# Value Engineering Study

Final Report

## Hal Rogers Parkway KY 30 to KY 192 (MP 1.089 to MP 3.877) Laurel County Item No. 11-365.00

May 25, 2022

VALUE ENGINEERING (VE) PROPOSAL NO. 04

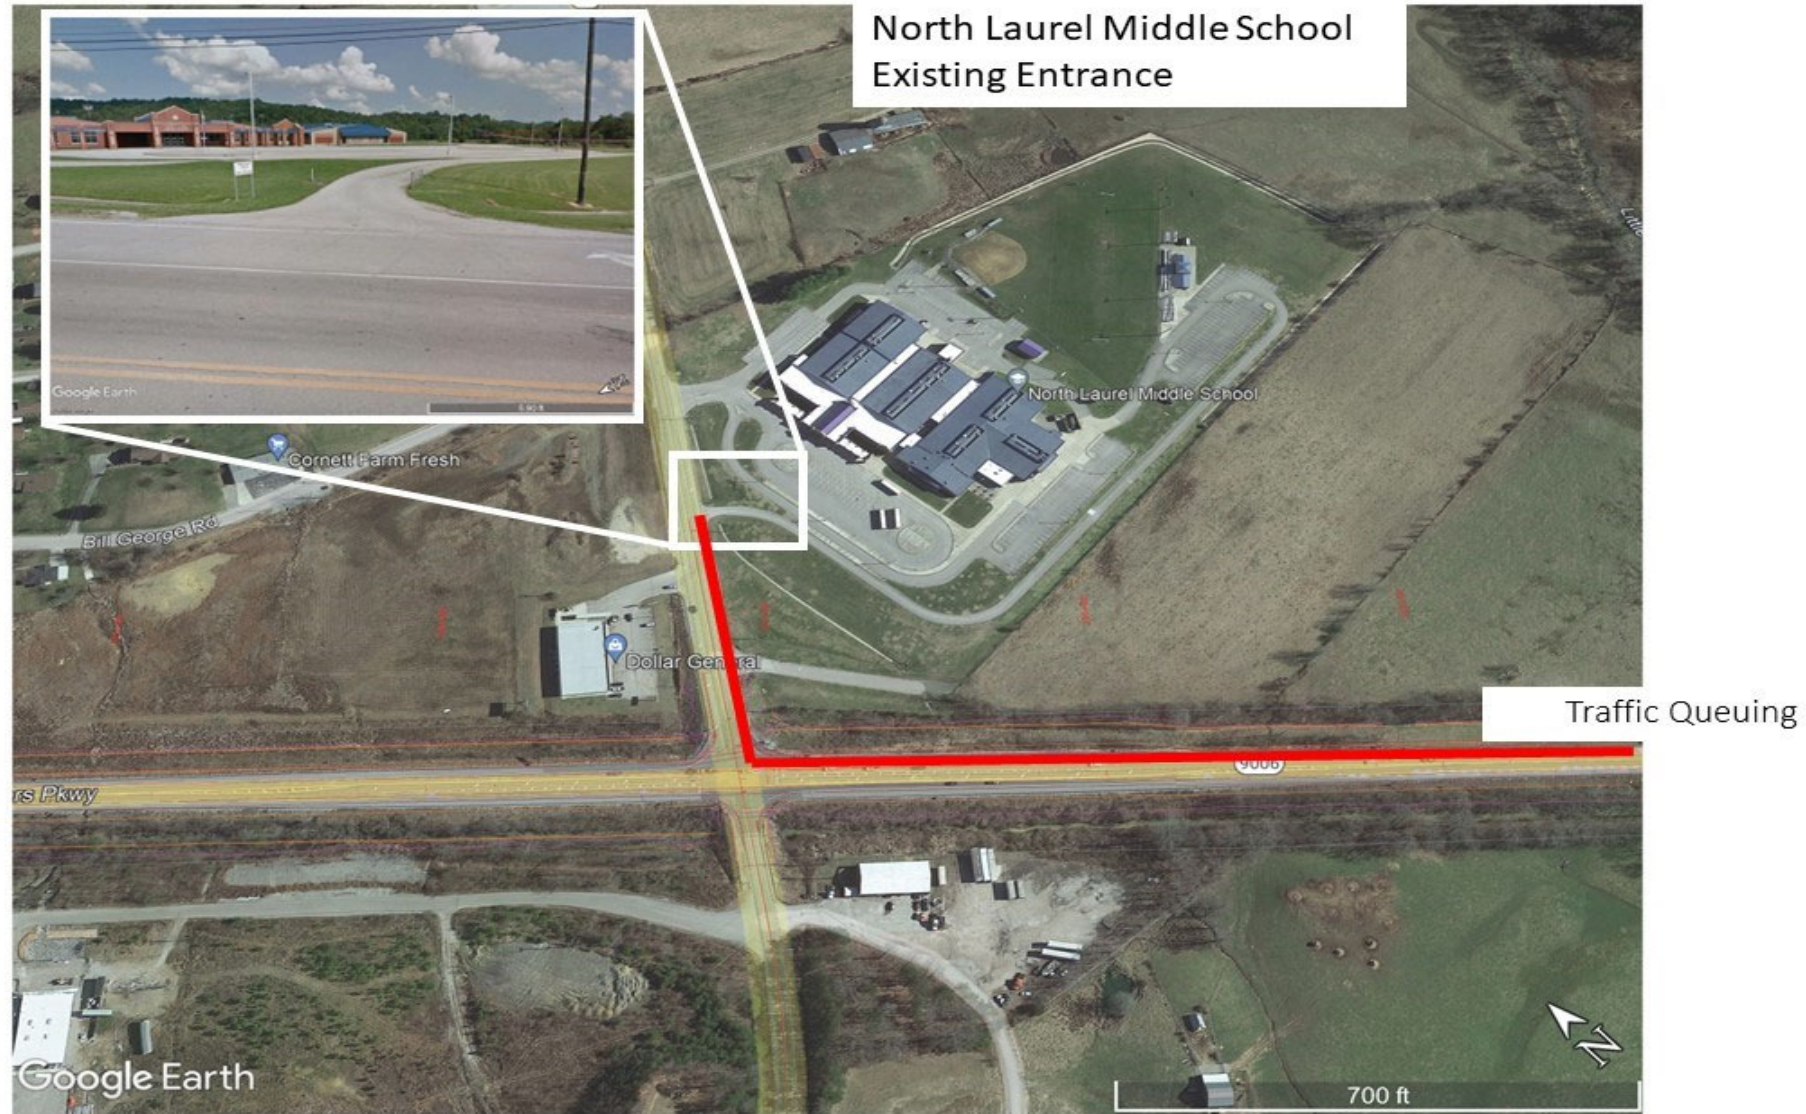
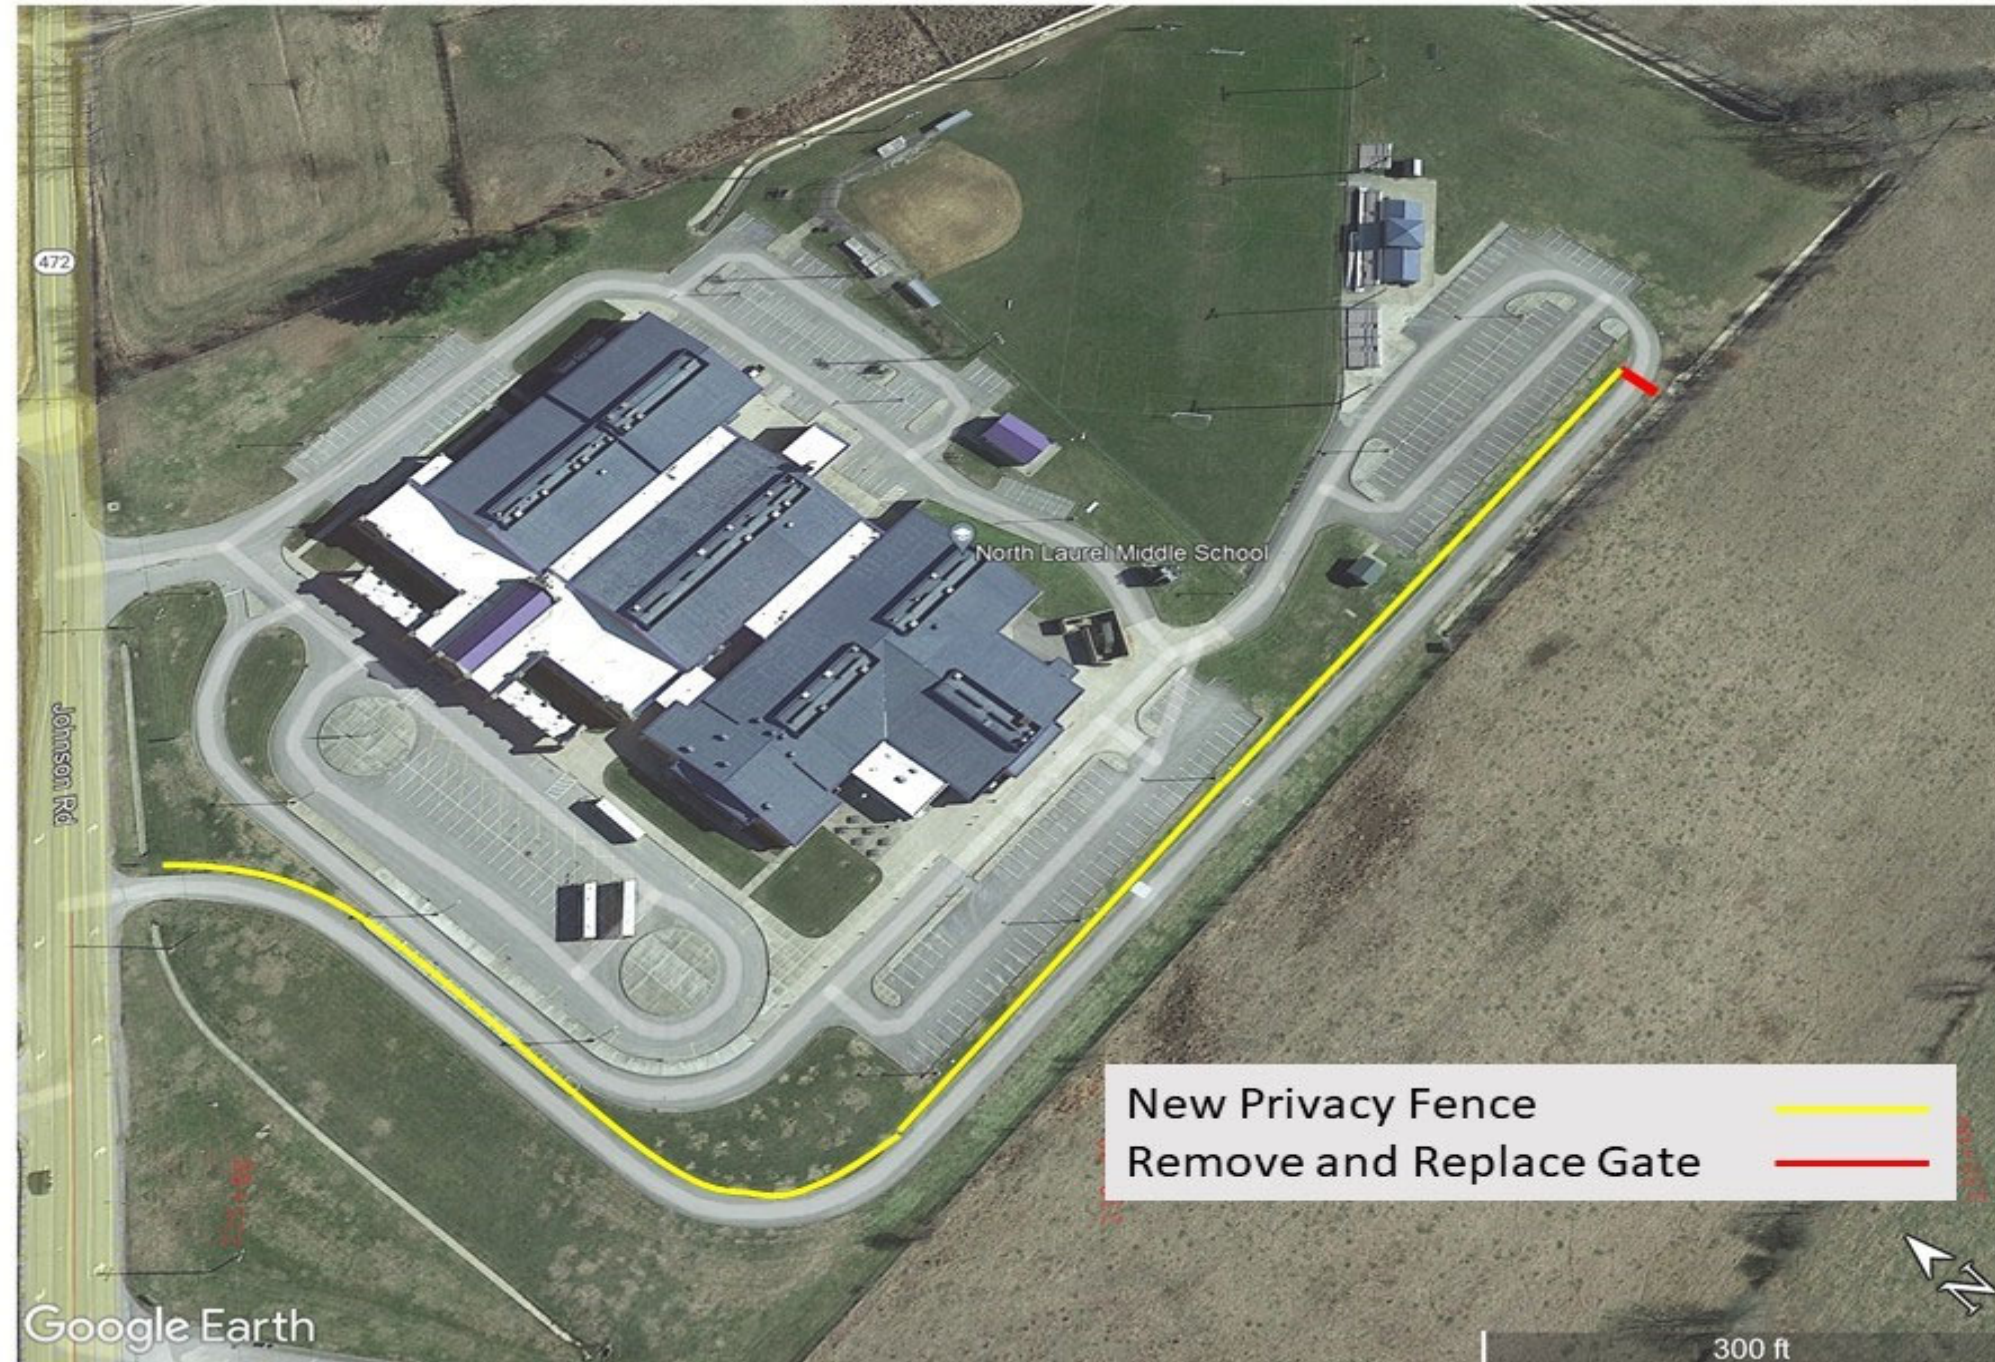
<b>TITLE</b>	Add security/barrier fence on middle school property to isolate road; relocate gate to back		
<b>FUNCTION</b>	<b>Increase Capacity (Improve traffic flow, reduce delay)</b>		
<b>VALUE PROPOSAL SYNOPSIS:</b>			
Moving the existing school gate 1325 feet to the back of the parking lot entrance provides additional vehicle storage. This will limit or eliminate the vehicle queuing onto existing Hal Rogers Parkway.			
 <b>Reliability</b>	<b>Improved</b>	 <b>Functionality</b>	<b>Improved</b>
 <b>O&amp;M</b>	<b>Maintained</b>	 <b>Schedule Impact</b>	<b>Improved</b>
			<b>\$ Initial Cost Avoidance (Add)</b>
			<b>(\$35,000)</b>
<b>BASELINE CONCEPT:</b>			
Currently there is a gate at the middle school entrance by KY 472 that is closed to pickups until a designated time. This causes vehicles arriving for student pickup to back up onto Hal Rogers Parkway (westbound).			
<b>VE PROPOSAL DESCRIPTION:</b>

Move the gate from the front of the entrance to the back of entrance drive approximately 1325 feet. Add privacy fence between the entrance and the school parking lot.			
<b>ADVANTAGES:</b>		<b>DISADVANTAGES:</b>	
● Adds additional vehicle storage for afternoon pickups		● Relies on school to follow through with moving gate	
● Improves safety by removing vehicles off Hal Rogers		● Adds cost	
● Improves congestion		● Disadvantage for the school - maintenance of the fence and having to mow and weed around the fence	
● Reduces delay		●	
● May reduce the need for pickups to arrive so early so they get in front of the queue and don't want to be late and backed out onto Hal Rogers		●	
● Safety advantage for the school - the privacy fence provides barrier between the pickup line and the school grounds		●	
<b>OVERALL PERFORMANCE SCORE</b>			<b>7.7</b>
<b>\$ COST SUMMARY</b>	<b>Initial Costs</b>	<b>O&amp;M Costs</b>	<b>Total Life Cycle Cost</b>

<b>TITLE</b>	Add security/barrier fence on middle school property to isolate road; relocate gate to back
<b>DISCUSSION &amp; JUSTIFICATION:</b>	
<p>The baseline alternate doesn't change the existing condition for the North Laurel Middle School Entrance. There is currently a gate that closes off access to the middle school until the a specific time for student pick up. This causes traffic to back up onto Hal Rogers Parkway until the gate opens. This alternative proposes to move the gate to the back of the middle school.</p> <p>This alternative would create 1325 feet of additional vehicle storage within the school. Due to security concerns for the school, we suggest adding a privacy fence along the entrance as shown in the proposed sketch. The Project Team stated that the middle school would be receptive to this option.</p> <p>The risk to project is that the operation of this alternative relies on the school to move the gate and open it at the appropriate times.</p> <p>A benefit of the option is that this alternative can be implemented regardless of the disposition of the overall project.</p>

**VALUE ENGINEERING (VE) PROPOSAL NO. 05**

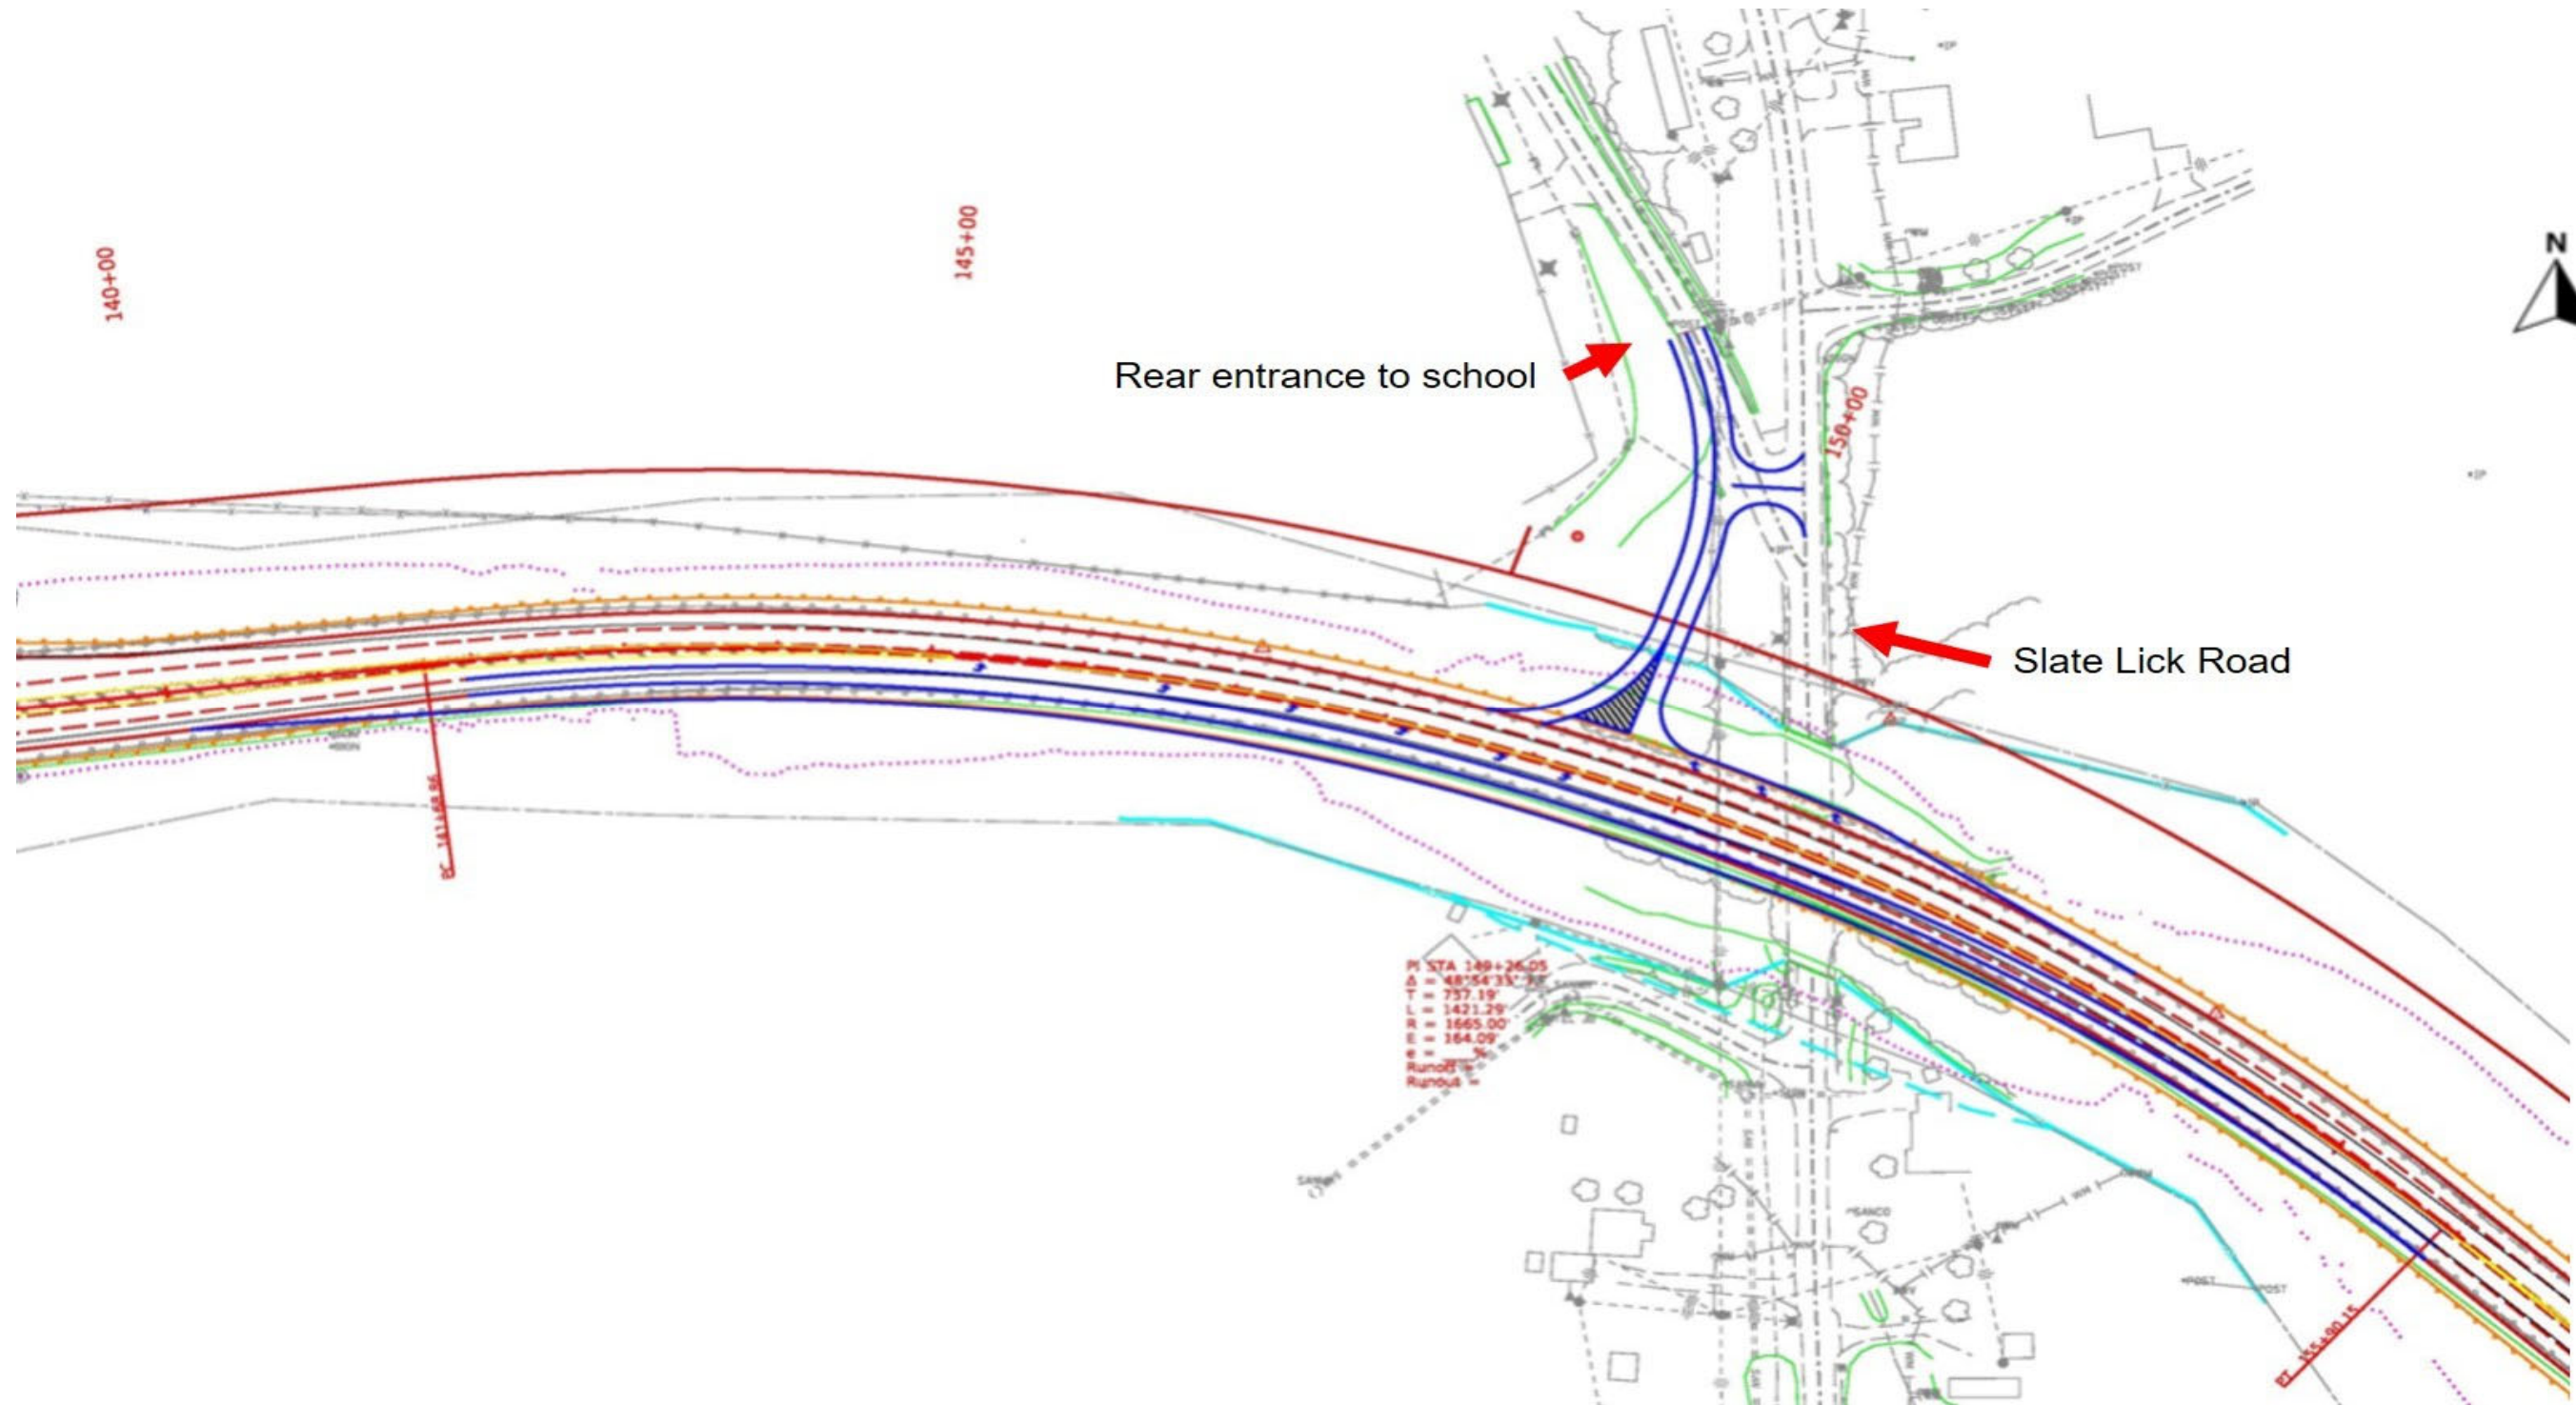
<b>TITLE</b>	Provide an additional access point to the rear entrance of the high school with a left-in and restricted left-out		
<b>FUNCTION</b>	<b>Increase Capacity (Improve traffic flow, reduce delay)</b>		
<b>VALUE PROPOSAL SYNOPSIS:</b>			
Allows students direct access to the rear student parking directly from Hal Rogers Parkway and will help alleviate some of the student traffic off of the current entrance during both peak am and pm traffic. Left out is restricted due to safety concerns; however, students can get onto Hal Rogers EB via the Slate Lick Bridge/Street to 638.			
 <b>Reliability</b>	<b>Improved</b>	 <b>Functionality</b>	<b>Improved</b>
 <b>O&amp;M</b>	<b>Maintained</b>	 <b>Schedule Impact</b>	<b>Maintained</b>
			<b>\$ Initial Cost Avoidance (Add)</b>
			<b>(\$274,000)</b>
<b>BASELINE CONCEPT:</b>			
The baseline does not provide direct access to the student parking lot directly from or to Hal Rogers Parkway.

<b>VE PROPOSAL DESCRIPTION:</b>			
Provides a new T-intersection to the Hal Rogers Parkway that is not proposed by the baseline. This new T-intersection allows students direct access to the rear student parking and will remove student traffic from bus traffic and parents dropping off students in the morning and bus traffic and parents picking up student in the afternoon.			
<b>ADVANTAGES:</b>		<b>DISADVANTAGES:</b>	
<ul style="list-style-type: none"> <li>● Reduces congestion during am and pm student, parent, and bus traffic</li> <li>● Works with VE Proposal No. 01 in justifying leaving Parkway 2 lanes as is with intersection improvements</li> <li>● Leaving parkway as is would eliminate bridge replacement</li> <li>● Provides an additional entrance that connects to Hal Rogers in case of an emergency and closure of the existing entrance</li> </ul>		<ul style="list-style-type: none"> <li>● Adds cost</li> <li>● New intersection to Hal Rogers creates more potential conflict points</li> <li>● Left turn lane needs to be added since baseline has 4-ft flush median in this area</li> <li>● Bridge will need to be lengthened to allow for left and right turn lanes</li> </ul>

<b>TITLE</b>	Provide an additional access point to the rear entrance of the high school with a left-in and restricted left-out
<b>DISCUSSION &amp; JUSTIFICATION:</b>	
<p>Adding a new entrance to the rear student parking has the potential to remove all of the students driving to school from the current entrance that is currently shared with bus traffic as well as parents either dropping off or picking up their kids. This should significantly reduce traffic at the existing entrance during the peak am and pm times, before school and just after school lets out.</p> <p>A short right turn lane will need to be added under the Slate Lick Bridge to allow WB traffic turning right from the Hal Rogers Parkway into this new rear entrance located west of the existing Slate Lick Bridge. This may be added behind the existing shoulder pier requiring a retaining wall to hold back the existing spill-through slope. A modified "Pork Chop" for right turns only exiting from the rear entrance to WB Hal Rogers is proposed to prevent left turns onto the Hal Rogers. Since the baseline has eliminated the 12-ft TWTL in this area by reducing it to a 4-ft flush median, a 12-ft left turn lane for EB Hal Rogers to this new entrance will need to be developed similar to the left turn lane into Professional Drive at Sta 165+00. The new 12-ft left turn lane and widening the flush median by 8-ft will require the center span of proposed Slate Lick Bridge to be lengthened by about 20-ft. The additional cost to add this new entrance and turn lanes as well as lengthening the bridge will be significant, but the benefits should more than outweigh the additional cost. We believe parents, students, and the community would be mostly in favor of the new entrance, and would have stakeholder acceptance. Reconfiguring Slate Lick Road rear entrance at the extreme skew will be a challenge in meeting traffic and safety requirements where they intersect.</p> <p>This will complement VE Proposal No. 01 to leave the parkway with a single lane in each direction but improve the intersections. Under this option, the existing Slate Lick Bridge can stay as is and will not need to be replaced, thus being a big cost savings rather than adding cost. The right turn lane can be constructed on the back side of the shoulder pier, using a retaining wall to cut back the existing spill-through slope. In fact, this could be constructed today as a standalone project.</p>
